FIELD TASK MODIFICATION REQUEST FORM REGARDING THE SAMPLING AND
ANALYSIS PLAN AND SAMPLING AND ANALYSIS PLAN ADDENDUM AT (SWMU 21) NSA
CRANE IN
02/07/2012
TETRA TECH INC

Tetra Tech, Inc.
FIELD TASK MODIFICATION REQUEST FORM

Project/Installation Name <u>NSA Crane, SWMU 21– Defense Reutilization Marketing Office (DRMO) Storage Lot</u>	CTO & Project Number <u>CTO F274; 112G02122</u>	Task Modification Number <u>001</u>
Modification to: <u>SWMU 21 Sampling and Analysis Plan (SAP), August 2010; and, SWMU 21 SAP Addendum, March 2011</u>	Site Location <u>NSA Crane</u>	Date of Request <u>February 7, 2012</u>

CONTRACT NUMBER	CTO NUMBER
APPROVED BY	DATE
APPROVED BY	DATE
FIGURE NO.	REV
FIGURE 5 - 1	0

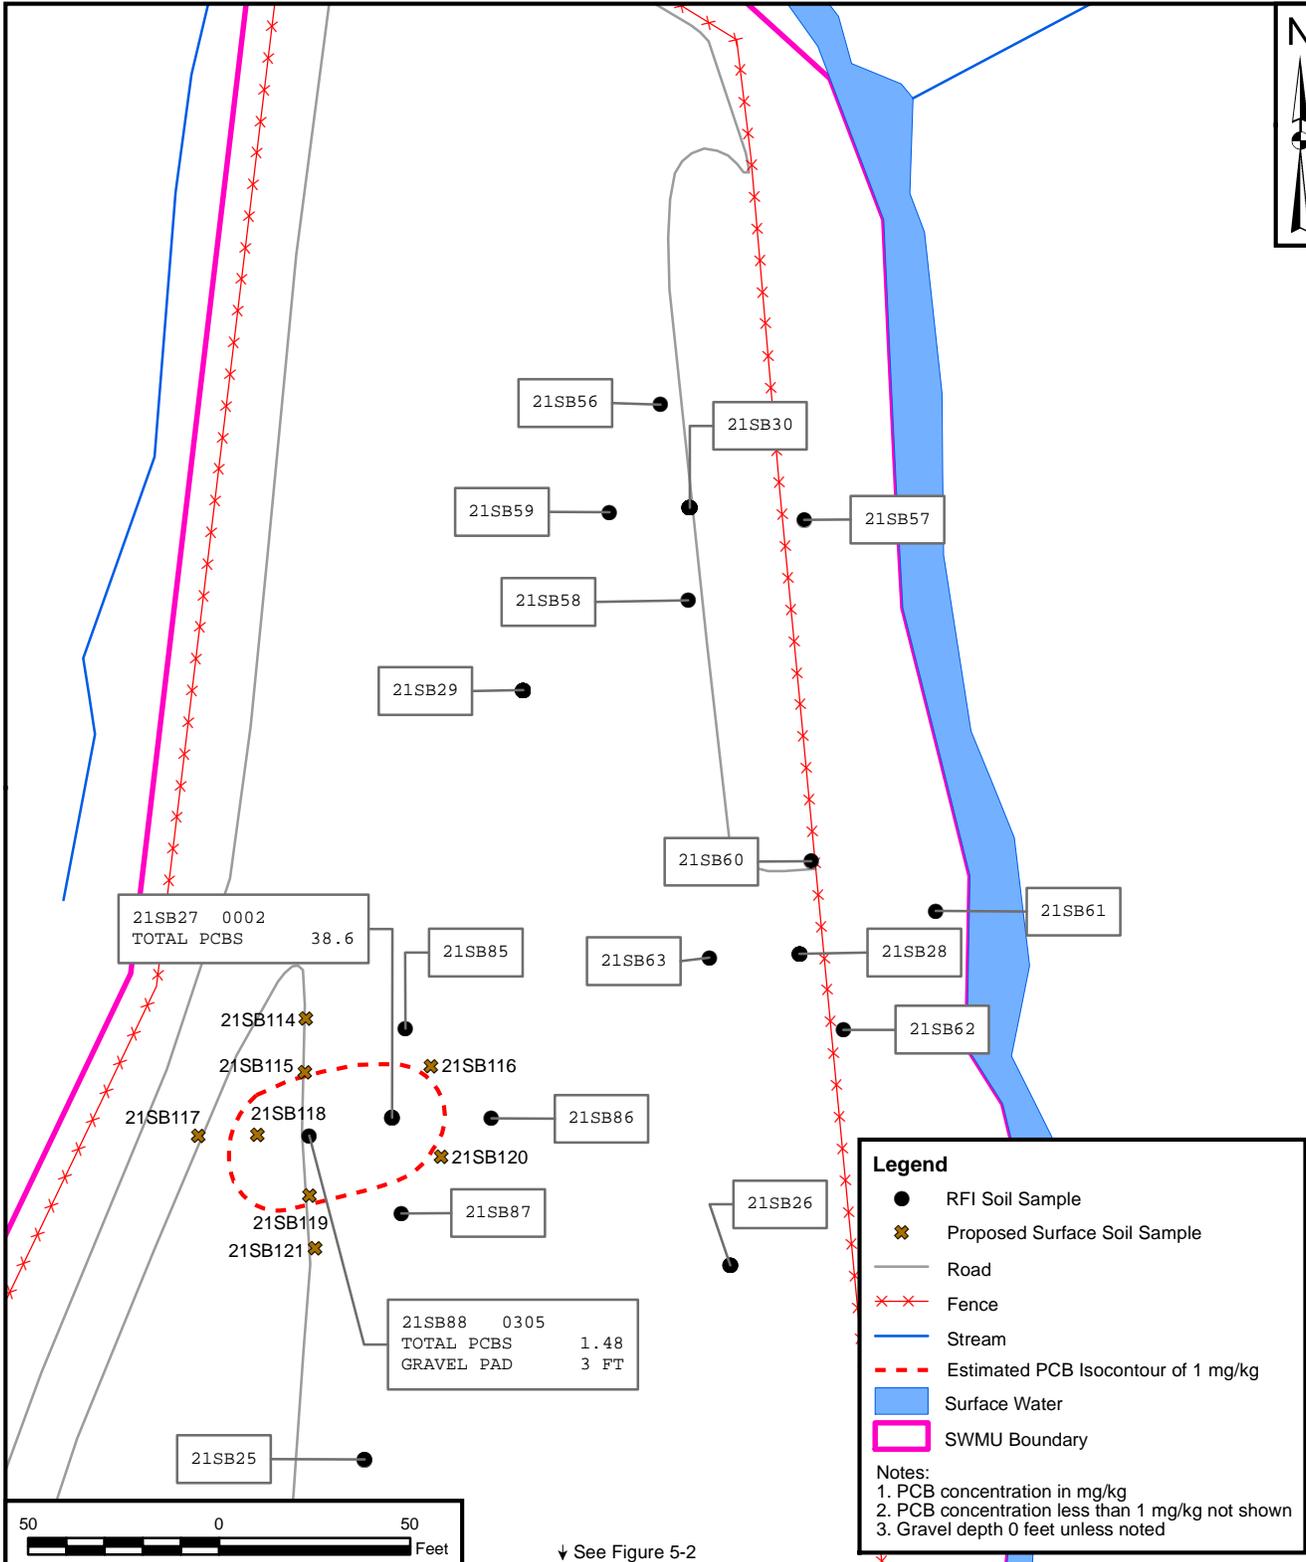
- **Northern North End.** Unbounded PCB contamination is in the area of soil borings 21SB27 and 21SB88 as shown on Figure 5-1. Eight surface soil samples will be collected in the areas immediately surrounding 21SB27 and 21SB88. Five surface soil samples, 21SB115, 21SB116, 21SB118, 21SB119, and 21SB120, will be extracted and immediately analyzed for PCBs. Three surface soil samples, 21SB114, 21SB117, and 21SB121 will be extracted and held for PCB analysis pending the results of the initial samples.

CONTRACT NUMBER	CTO NUMBER
APPROVED BY	DATE
APPROVED BY	DATE
FIGURE NO.	REV
FIGURE 5 - 2	0

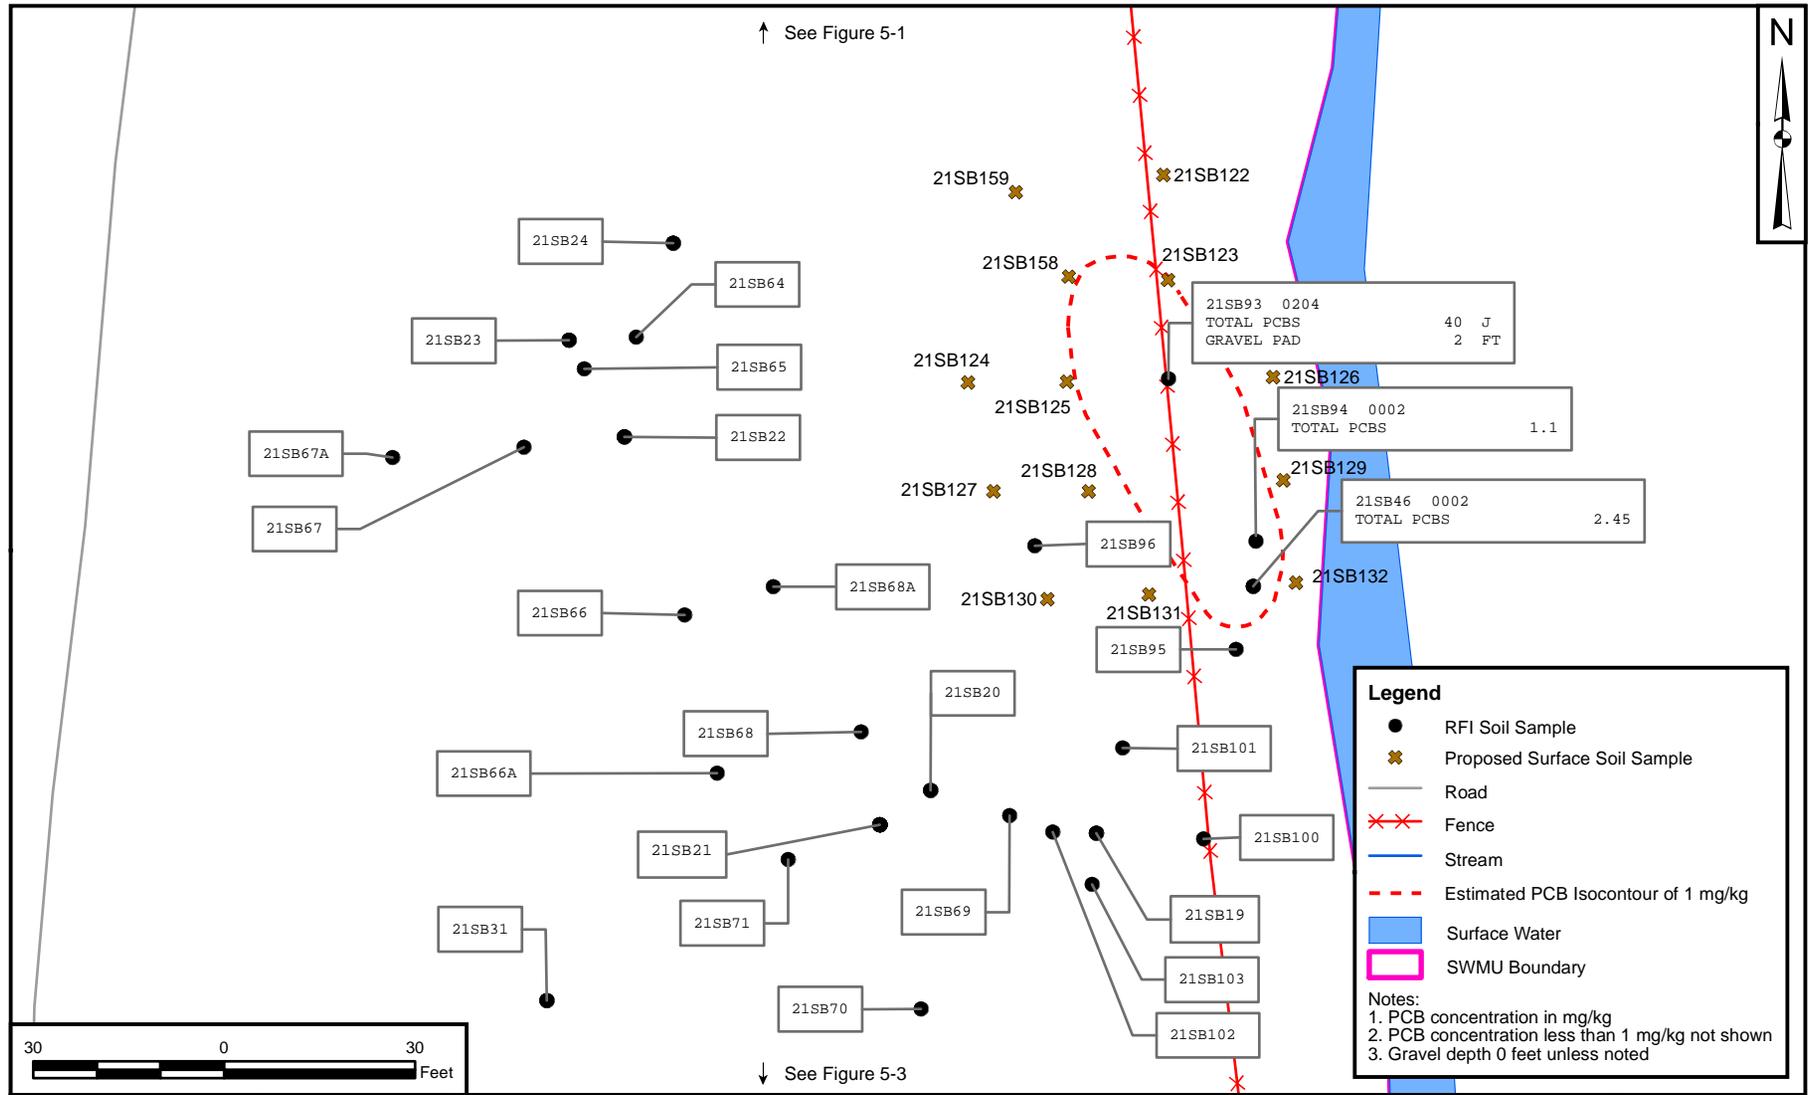
- **Southern North End.** Unbounded PCB contamination is shown in the area of soil borings 21SB46, 21SB93, and 21SB94 as shown on Figure 5-2. Thirteen surface soil samples will be collected in the areas immediately surrounding 21SB46, 21SB93, and 21SB94. Eight surface soil samples, 21SB123, 21SB125, 21SB126, 21SB128, 21SB129, 21SB131, 21SB132, and 21SB158 will be extracted and immediately analyzed for PCBs. Five surface soil samples, 21SB122, 21SB124, 21SB127, 21SB130, and 21SB159 will be extracted and held for PCB analysis pending the results of the initial samples.

CONTRACT NUMBER	CTO NUMBER
APPROVED BY	DATE
APPROVED BY	DATE
FIGURE NO.	REV
FIGURE 5 - 3	0

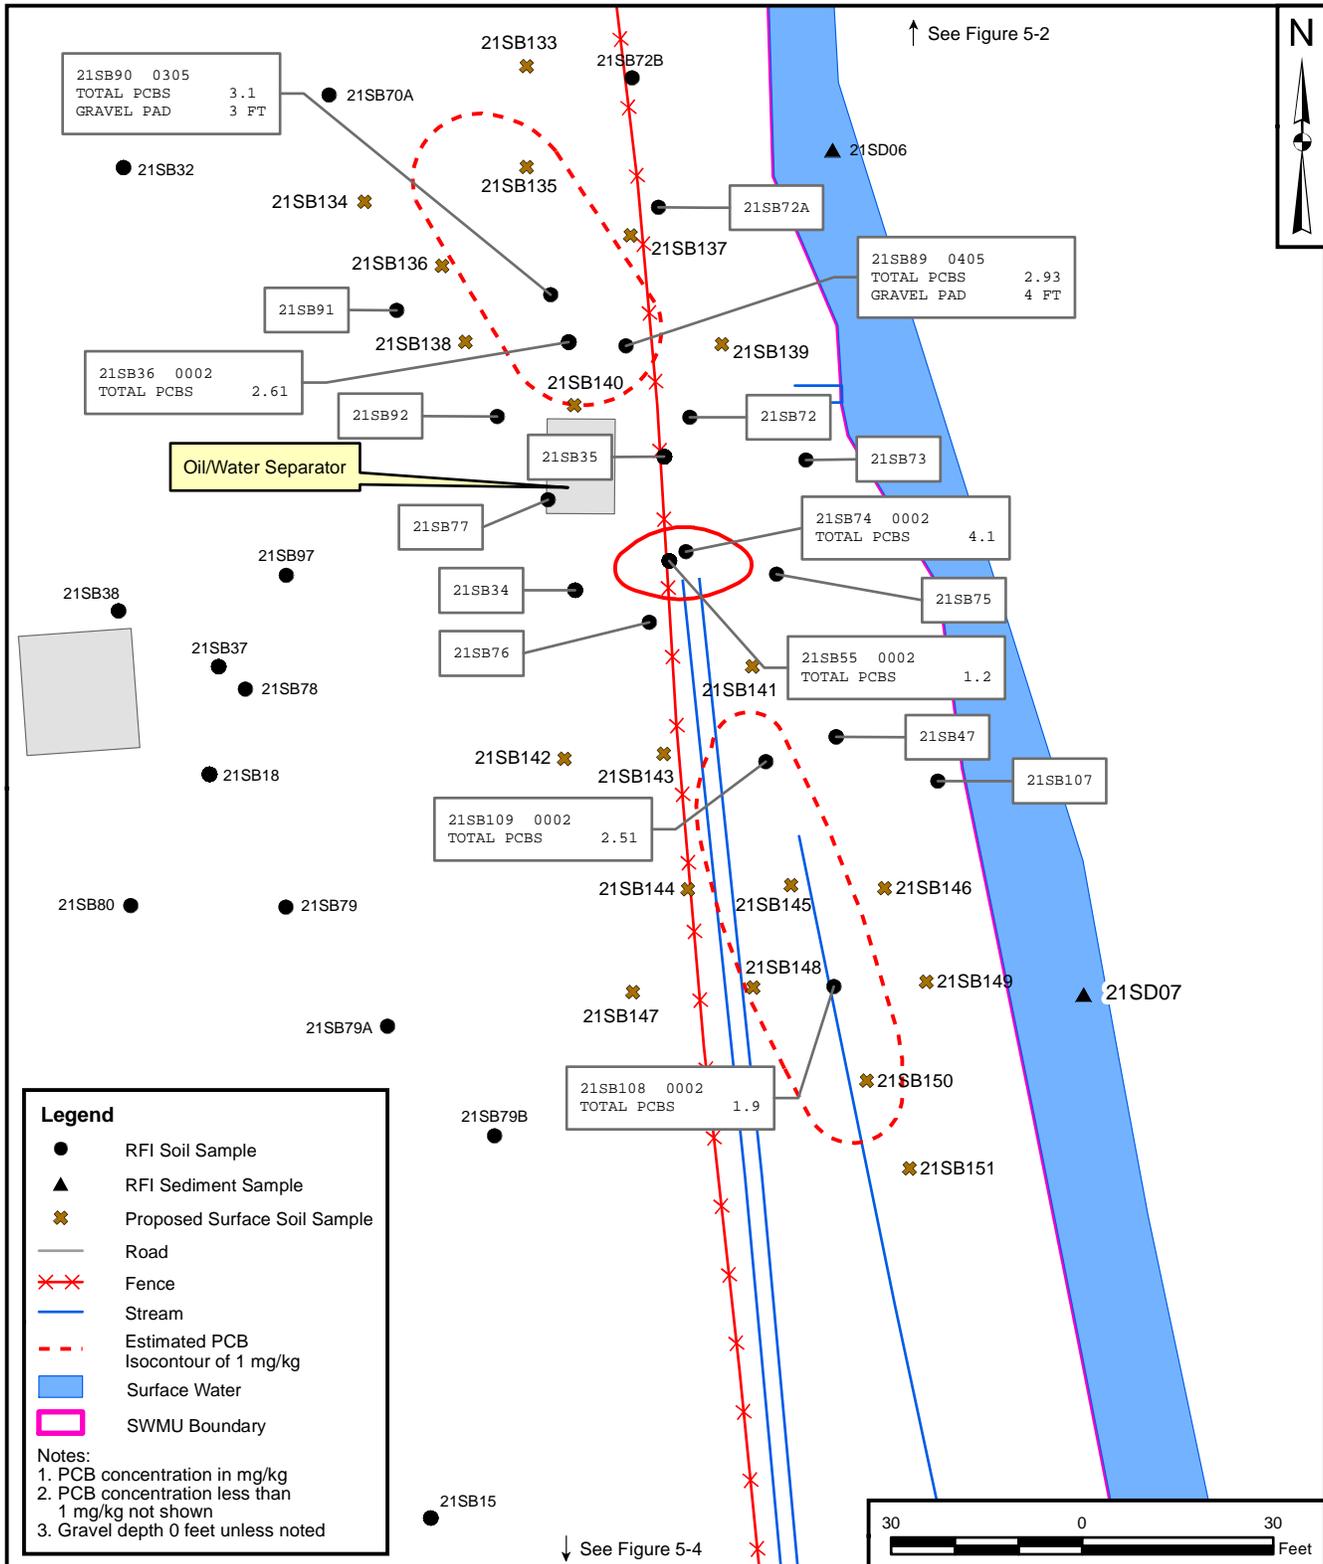
- **North of Oil/Water Separator (OWS).** Unbounded PCB contamination is shown in the area of soil boring 21SB36, 21SB89, and 21SB90 as shown on Figure 5-3. Eight surface soil samples will be collected in the areas immediately surrounding 21SB36, 21SB89, and 21SB90. Six surface soil samples, 21SB135, 21SB136, 21SB137, 21SB138, 21SB139, and 21SB140, will be extracted and immediately analyzed for PCBs. Two surface soil samples, 21SB133 and 21SB134, will be extracted and held for PCB analysis pending the results of the initial samples.

- **South of Oil/Water Separator (OWS).** Unbounded PCB contamination is shown in the area of soil boring 21SB108 and 21SB109 as shown on Figure 5-3. Eleven surface soil samples are recommended to be collected in the area immediately surrounding 21SB108 and 21SB109. Eight surface soil samples, 21SB141, 21SB143, 21SB144, 21SB145, 21SB146, 21SB148, 21SB149, and 21SB150, will be extracted and immediately analyzed for PCBs. Three surface soil samples, 21SB142, 21SB147, and 21SB151, will be extracted and held for PCB analysis pending the results of the initial samples.

CONTRACT NUMBER	CTO NUMBER
APPROVED BY	DATE
APPROVED BY	DATE
FIGURE NO.	REV
FIGURE 5 - 5	0

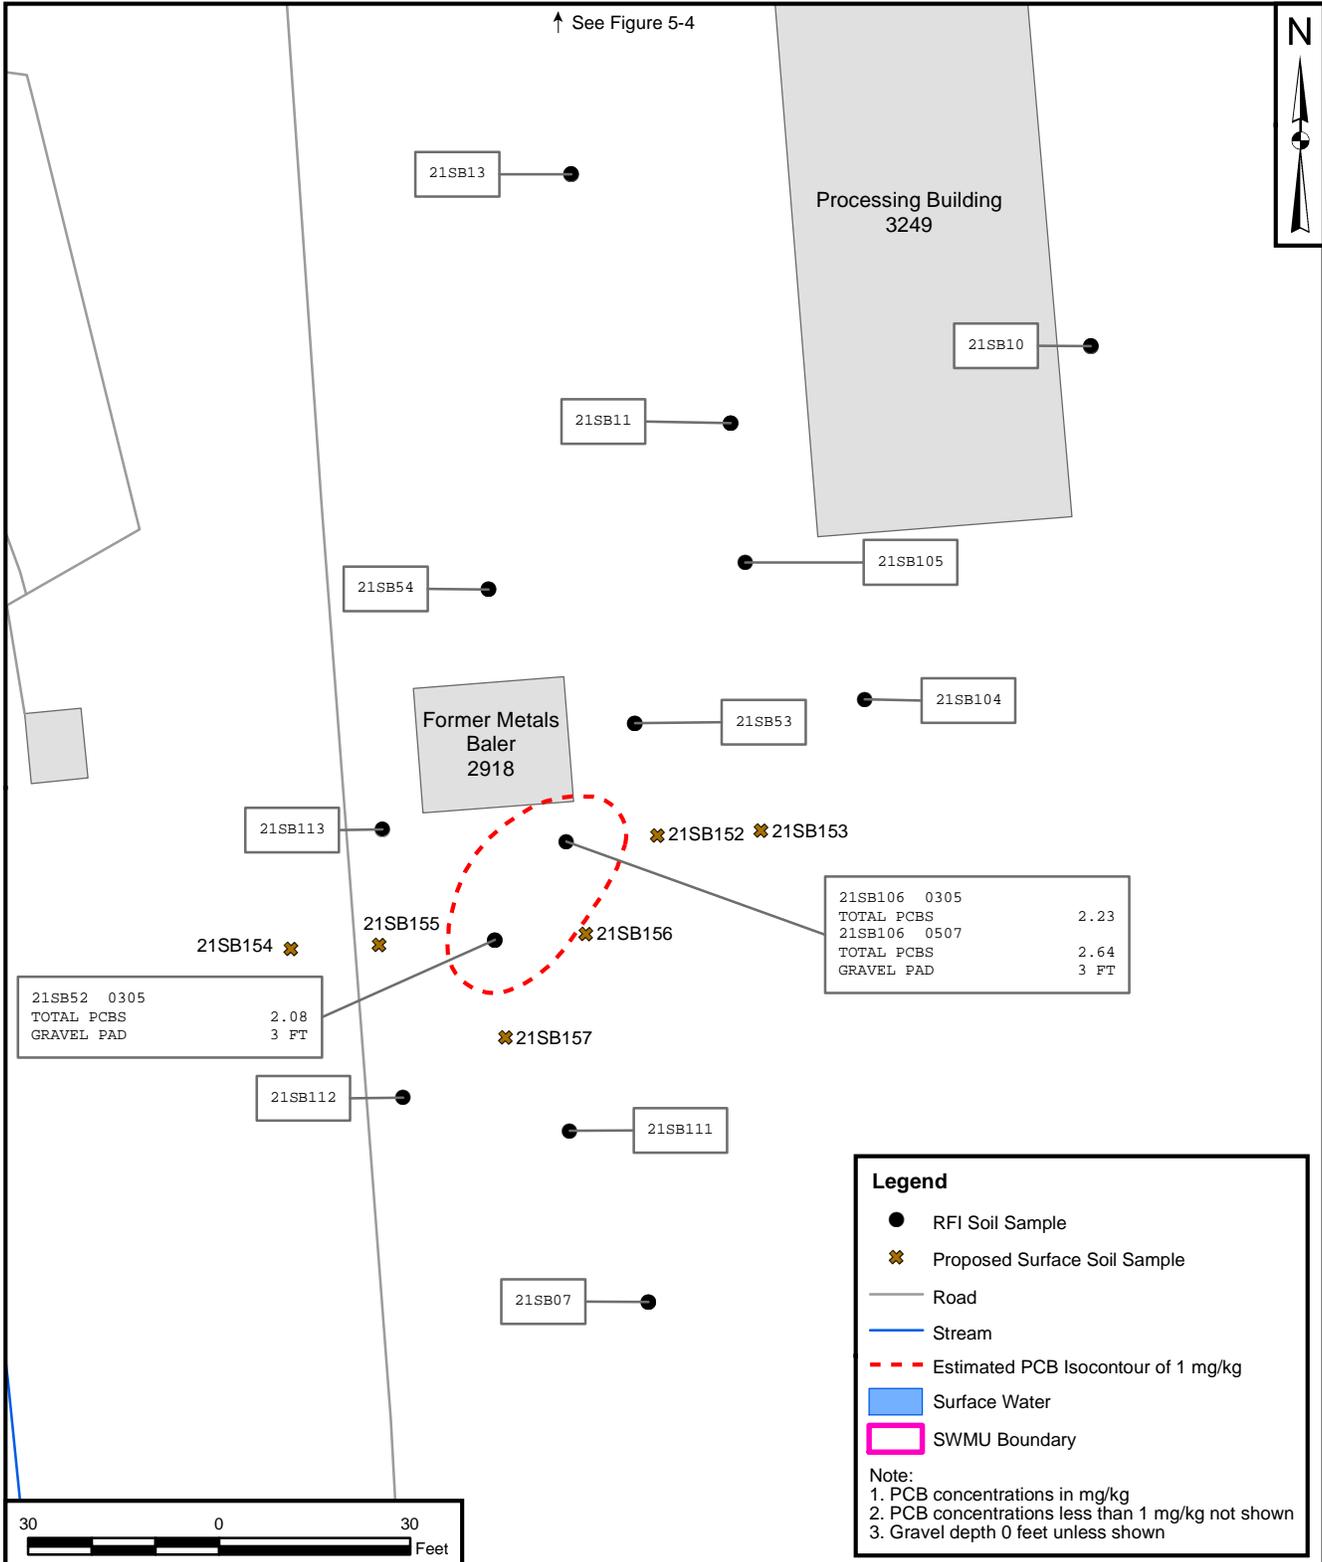
- **Metals Baler.** Unbounded PCB contamination is shown in the area of soil boring 21SB52 and 21SB106 as shown on Figure 5-5. Six surface soil samples are recommended to be collected in the area immediately surrounding 21SB52 and 21SB106. Four surface soil samples, 21SB152, 21SB155, 21SB156, and 21SB157, will be extracted and immediately analyzed for PCBs. Two surface soil samples, 21SB153 and 21SB154, will be extracted and held for PCB analysis pending the results of the initial samples.
